ADDENDUM #1 - 6/16/2025
REVISED SHEETS: D-1, D-2, D-7, INT-2, INT-3, P-1, P-2, P-4, U-1, U-2, U-3, U-5, W-1, W-2, W-5, W-7, E-1, E-2, E-4, E-7, AND E-8.
REVISION #1 - 8/28/2025
REVISED SHEETS: D-6, INT-2, INT-3, INT-4, INT-6, INT-7, P-1, P-2, P-3, P-4, P-5, P-6, U, W, E, AND ALL X SHEETS.
REVISION #2 - 11/10/2025
REVISED SHEETS: D-6, D-7, INT 1 - INT 4, INT-6, P-1, P-2, P-4, U-1 - U-7, U-12 - U-15, W-3, X-1 - X-7, X-9, AND X-10.

CITY ENGINEERING DIVISION
DEPARTMENT OF PUBLIC WORKS
PLAN OF PROPOSED IMPROVEMENT

E. MAIN STREET & S. HANCOCK STREET
ASSESSMENT DISTRICT - 2025

CITY PROJECT NO. 15125
CONTRACT NO. 8784

15125
D-1

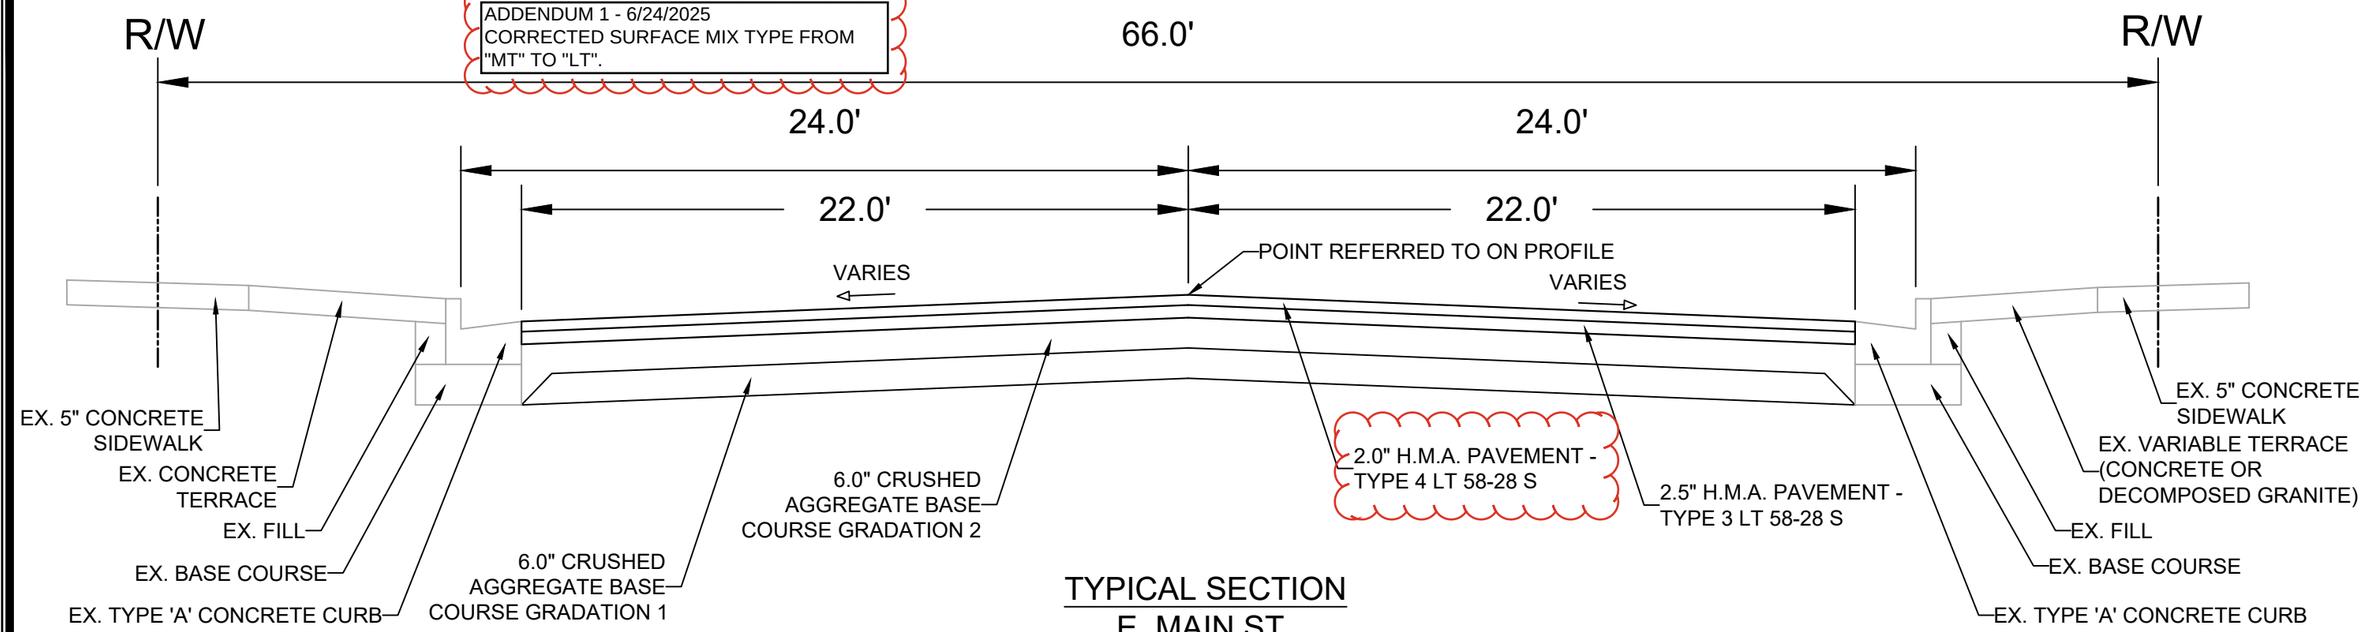
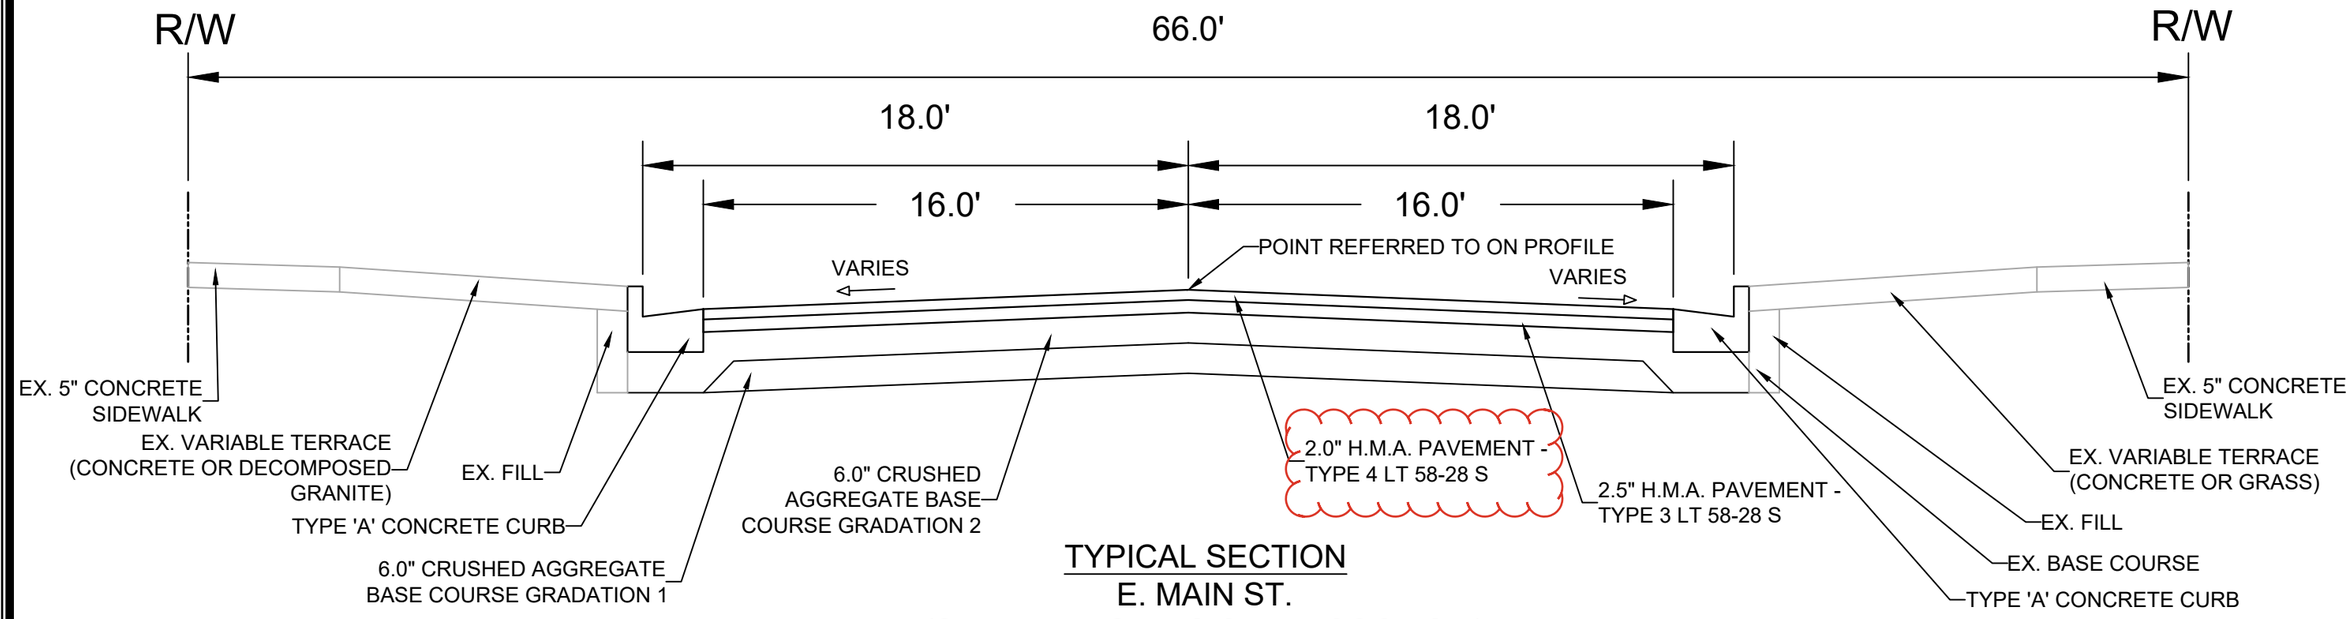
ADDENDUM 1 - 6/24/2025
CORRECTED SURFACE MIX TYPE FROM "MT" TO "LT".

15125
D-2

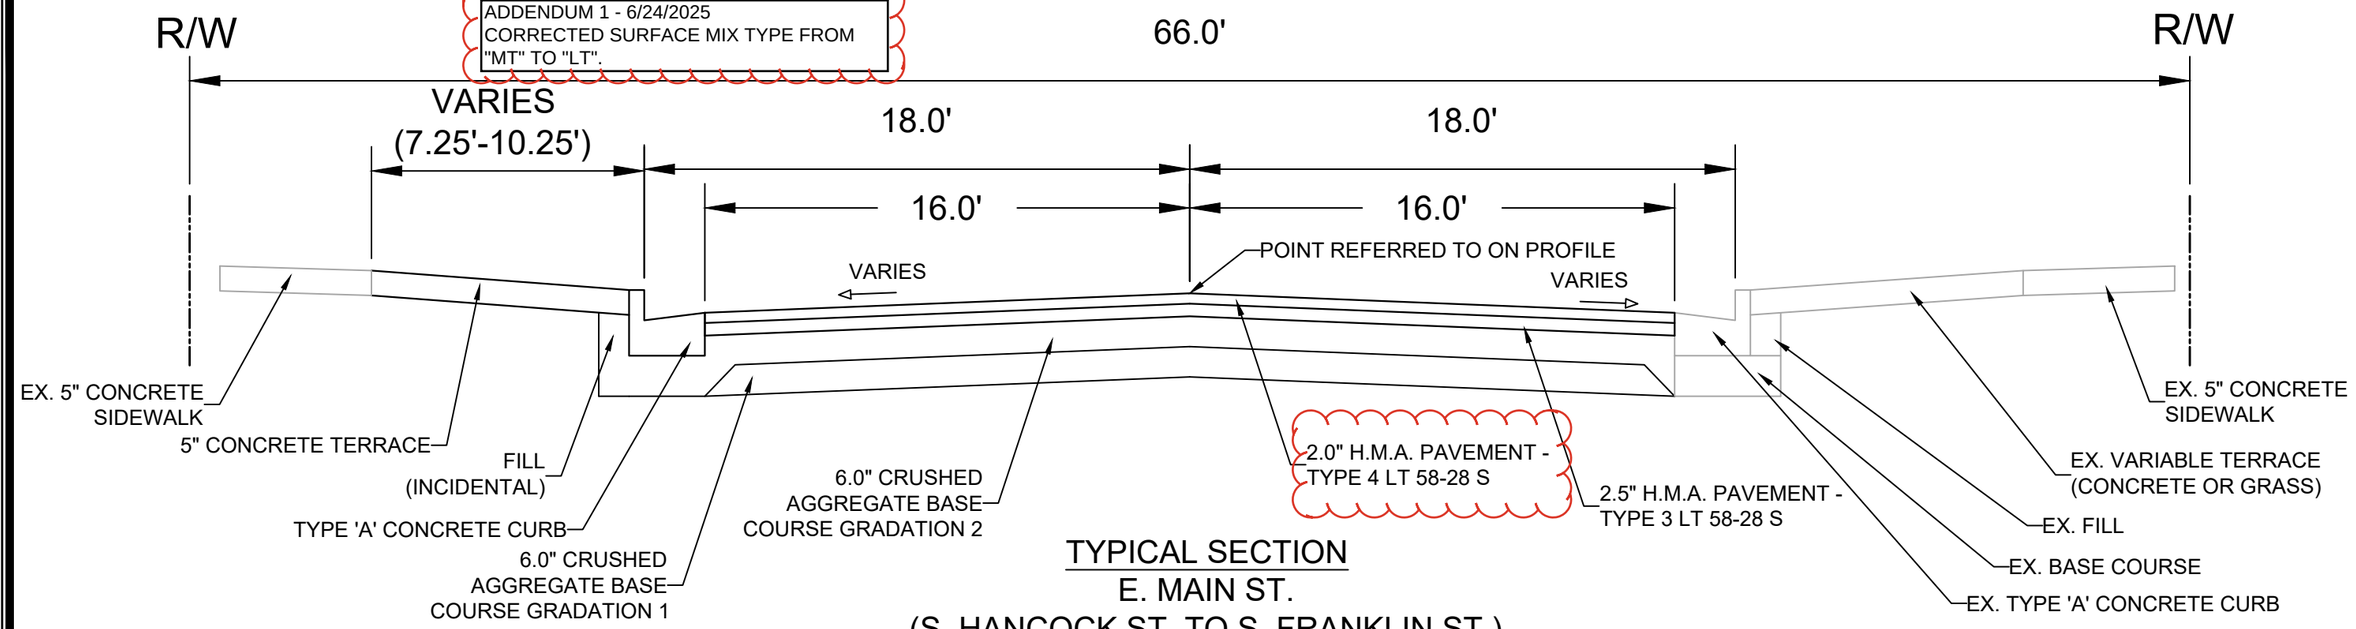
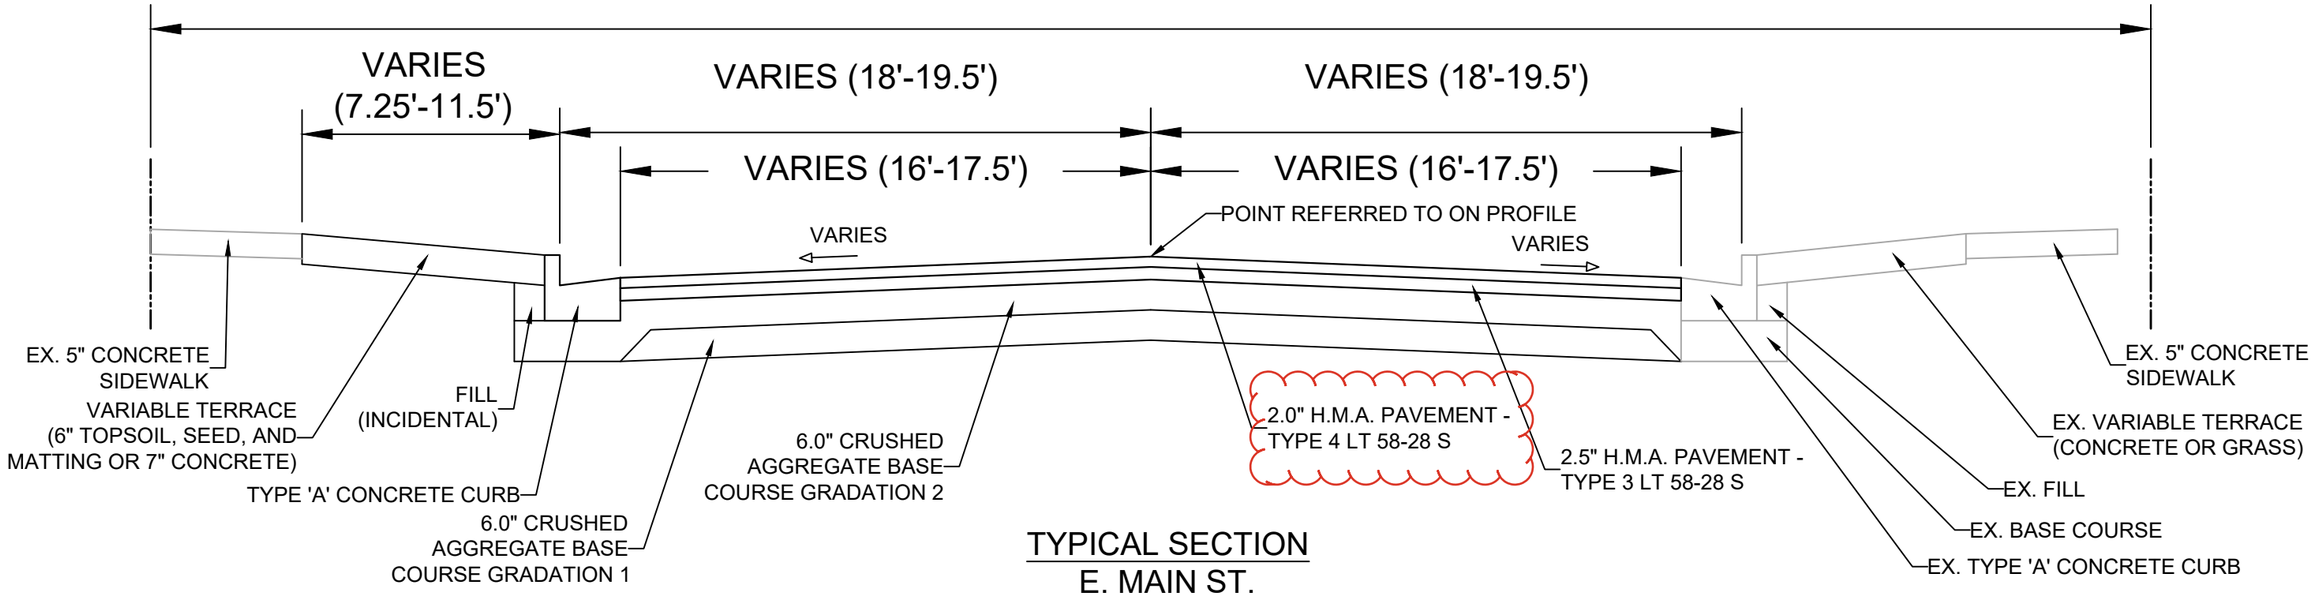
ADDENDUM 1 - 6/24/2025
CORRECTED SURFACE MIX TYPE FROM "MT" TO "LT".

DETAIL: TSS-1, TSS-2, TSS-3

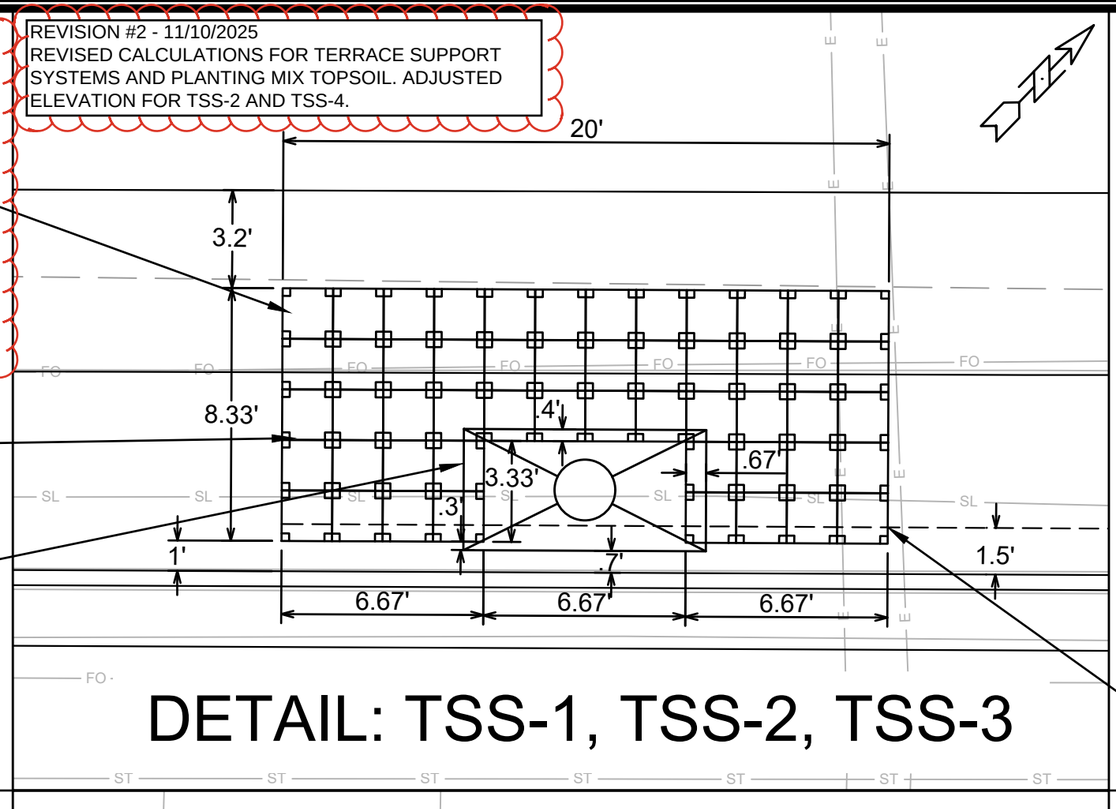
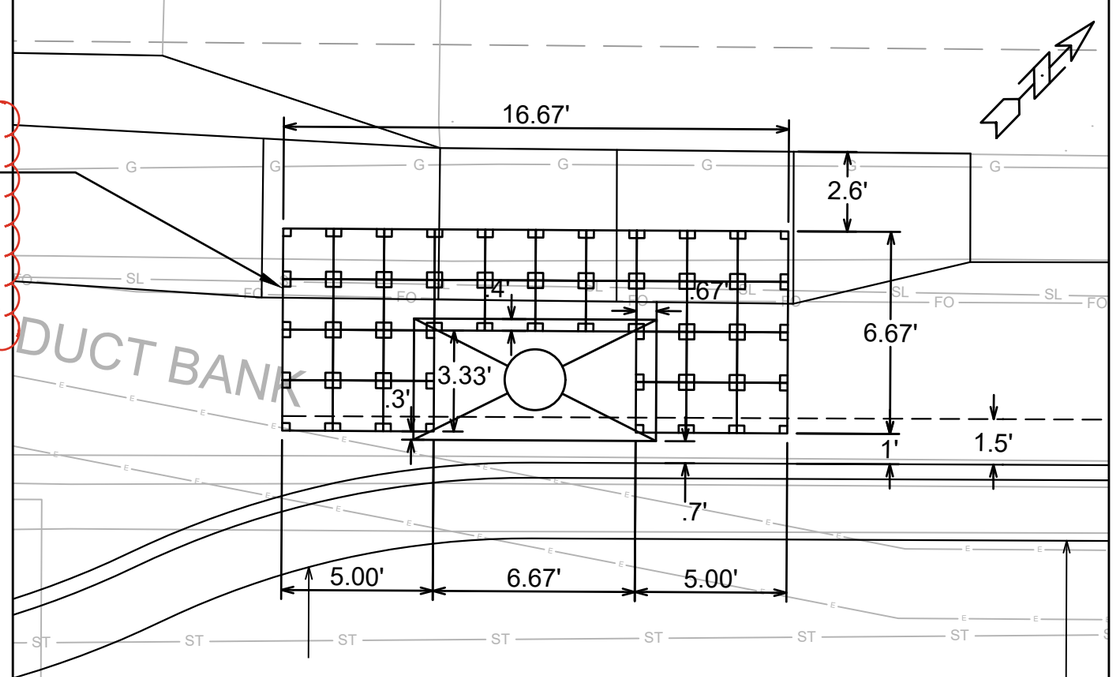
REVISION #2 - 11/10/2025
REVISED CALCULATIONS FOR TERRACE SUPPORT SYSTEMS AND PLANTING MIX TOPSOIL. ADJUSTED ELEVATION FOR TSS-2 AND TSS-4.

S HANCOCK ST- PLAN & PROFILE

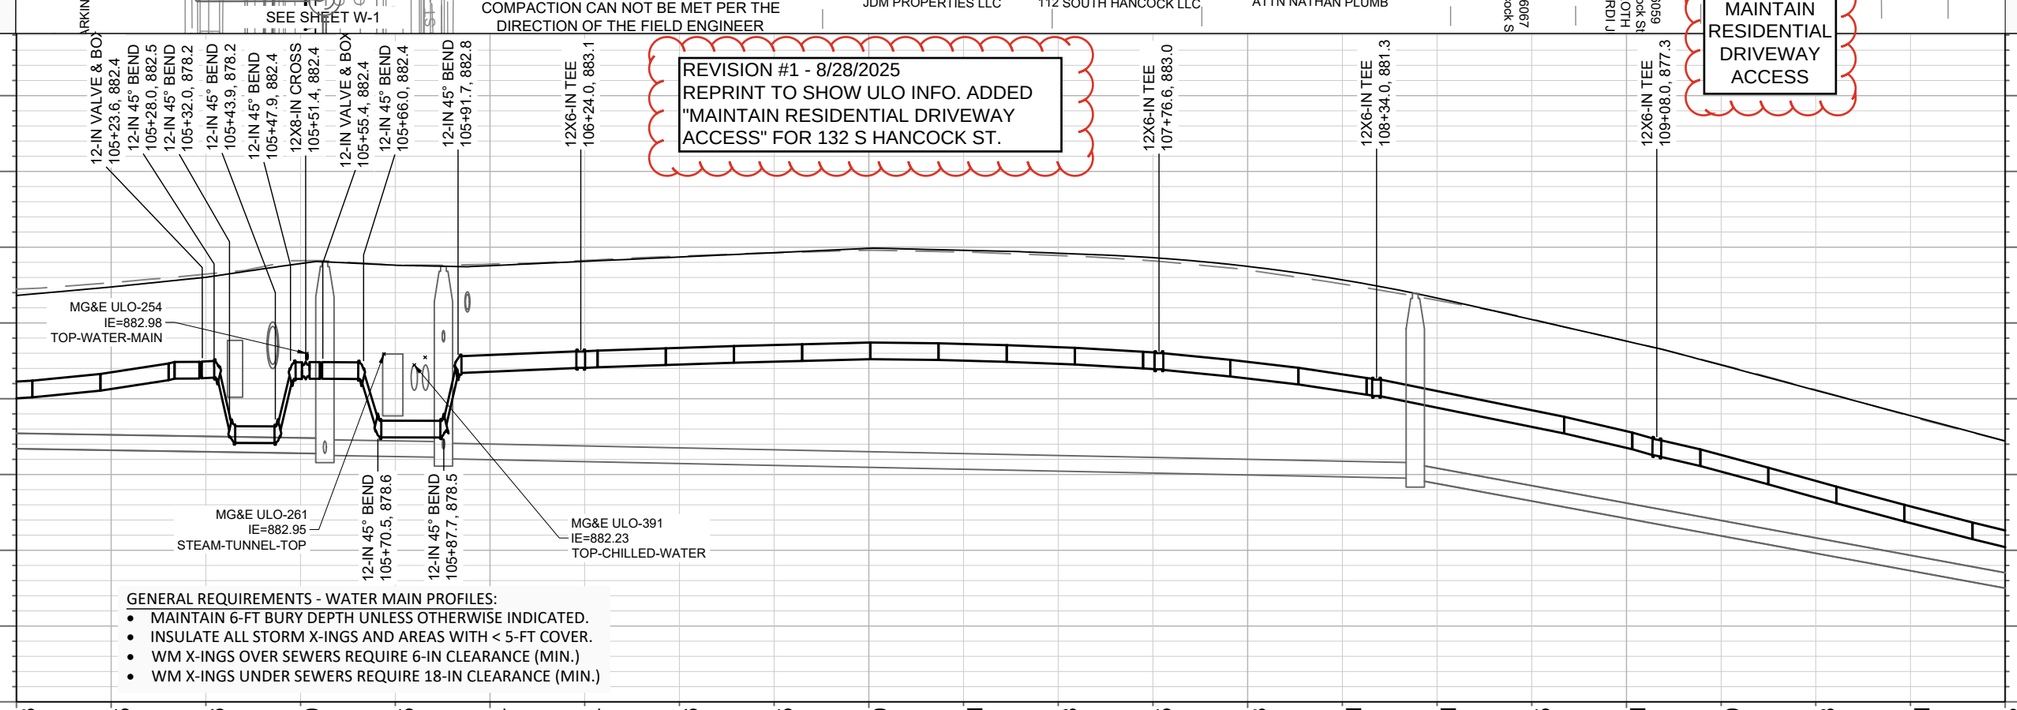
REVISION #1 - 8/28/2025
REPRINT TO SHOW ULO INFO. ADDED
"MAINTAIN RESIDENTIAL DRIVEWAY
ACCESS" FOR 132 S HANCOCK ST.

PM-7

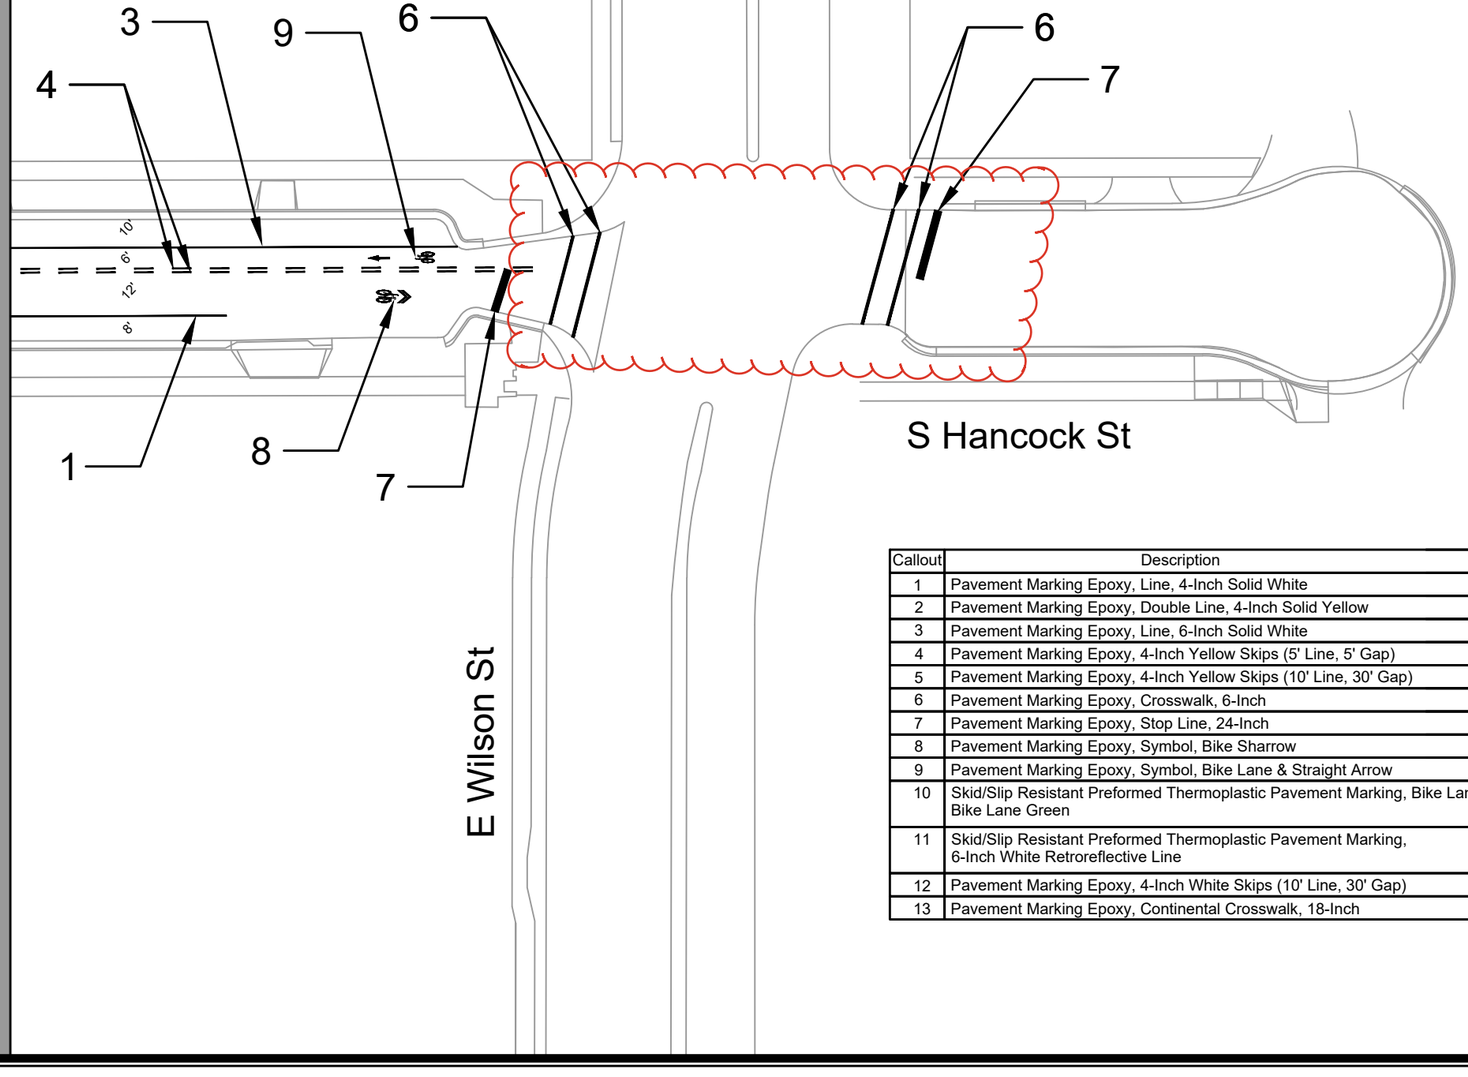
ADDENDUM 1 - 6/24/2025
1. INCREASED CURB REMOVAL/REPLACEMENT ON SOUTHWEST SIDE OF S. HANCOCK STREET.
2. ADJUSTED CROSSWALK MARKINGS TO MATCH EXISTING GEOMETRY.

CROSS SECTIONS - E. MAIN STREET

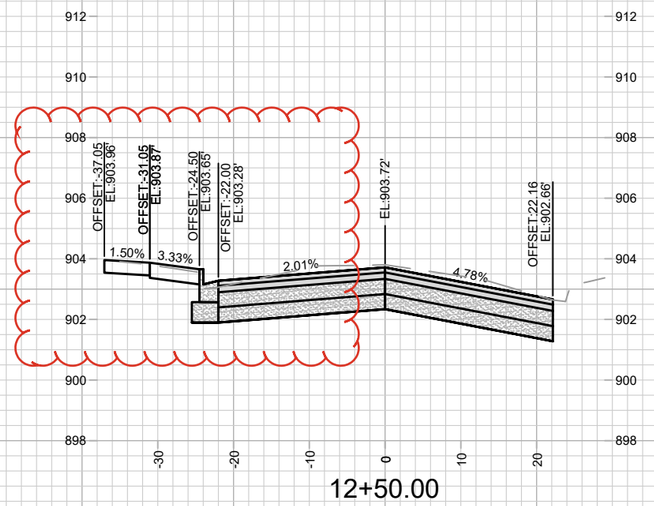
REVISION #1 - 8/28/2025
ADJUSTED MAIN ST CENTERLINE GRADES.

14+25.00

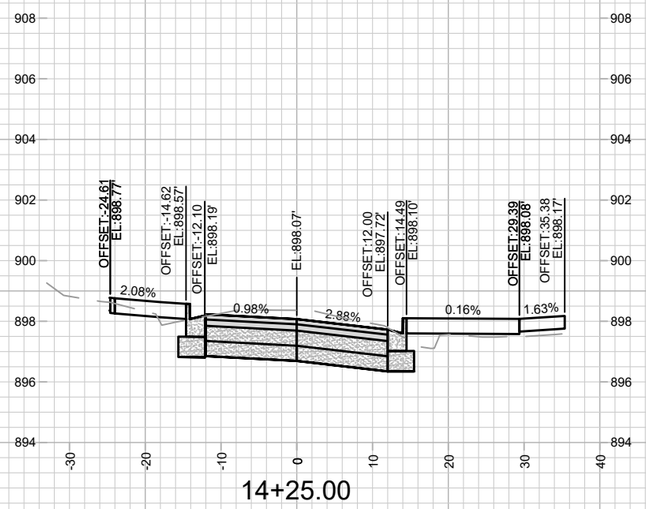
REVISION #2 - 11/10/2025
ADJUSTED LT EP.
